From: Feeney, John M - DNR
Sent: Monday, January 11, 2016 9:40 AM
To: 'Nicole L. LaPlant'
Subject: RE: Proposed Soil Borings - Quality Cleaners, Grafton, WI (BRRTS #02-46-560212)

From: Nicole L. LaPlant [<mailto:nlaplant@releeinc.com>]
Sent: Monday, January 04, 2016 4:10 PM
To: Feeney, John M - DNR
Cc: Chris Sitzmann
Subject: Proposed Soil Borings - Quality Cleaners, Grafton, WI (BRRTS #02-46-560212)

● = proposed soil boring location by REL

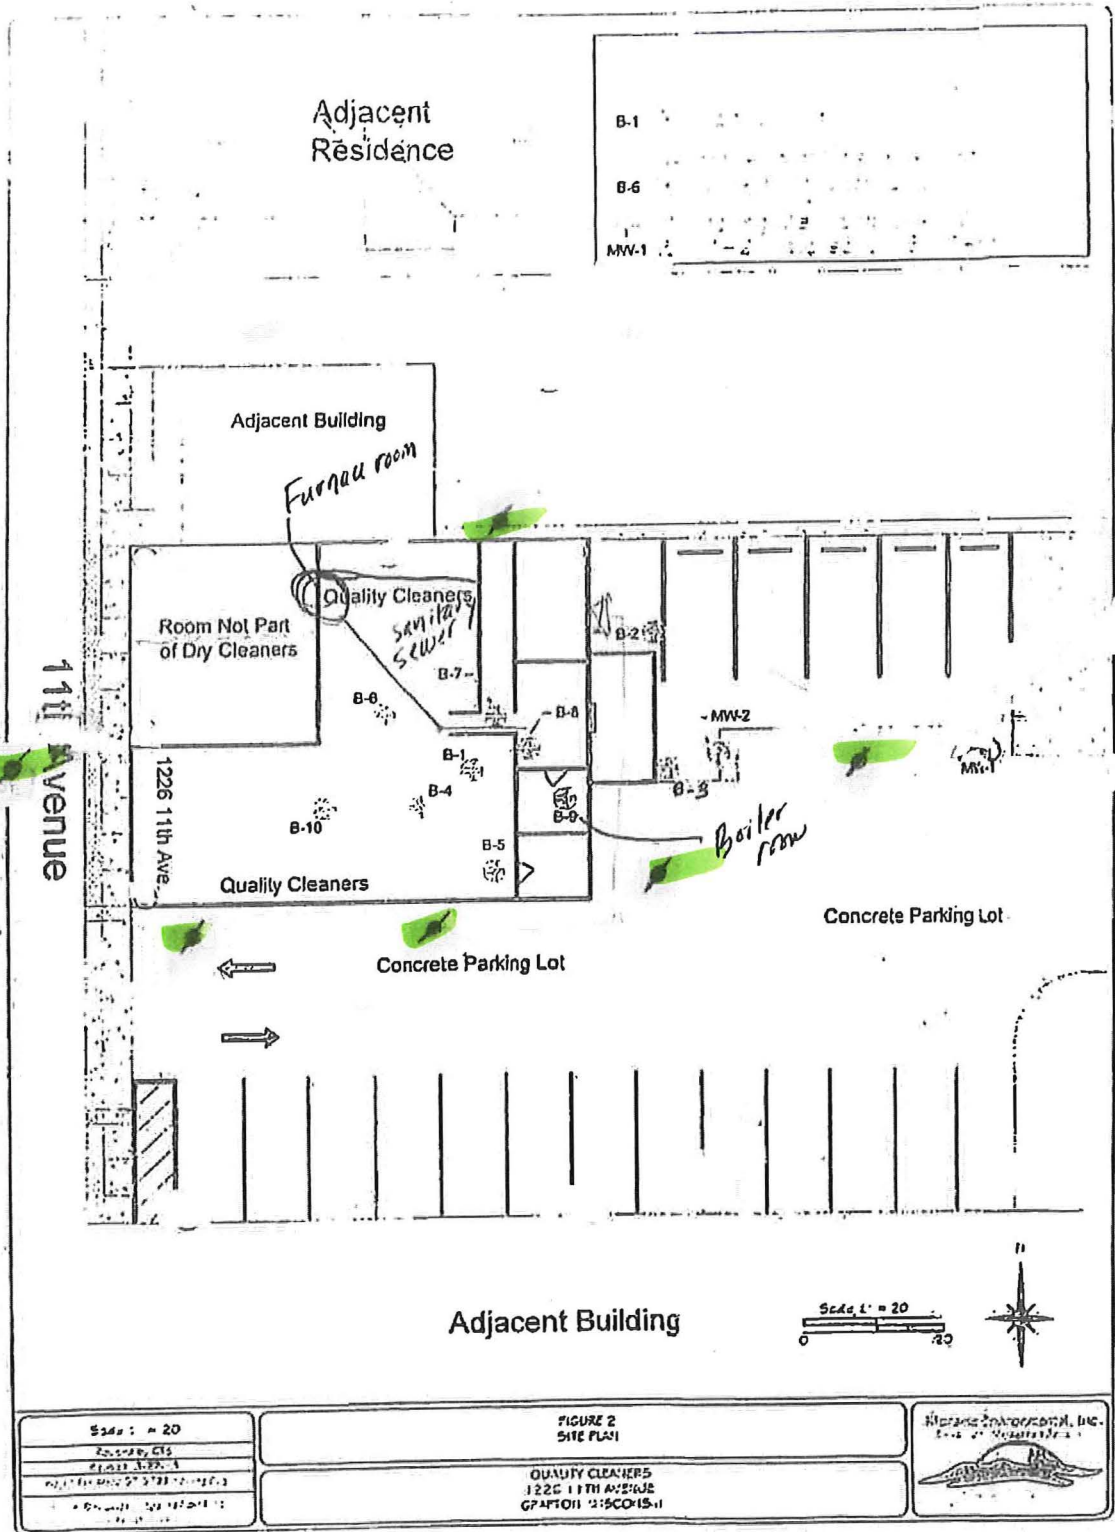
Hi Nicole. I looked at your proposed borings. I think you should include sub-slab sampling in the adjacent building and/or residence. Also consider adding a boring to the south near the parking stalls, and one between the adjacent building and residence to the north. Your chances of getting the full extent defined on the next round increase that way.
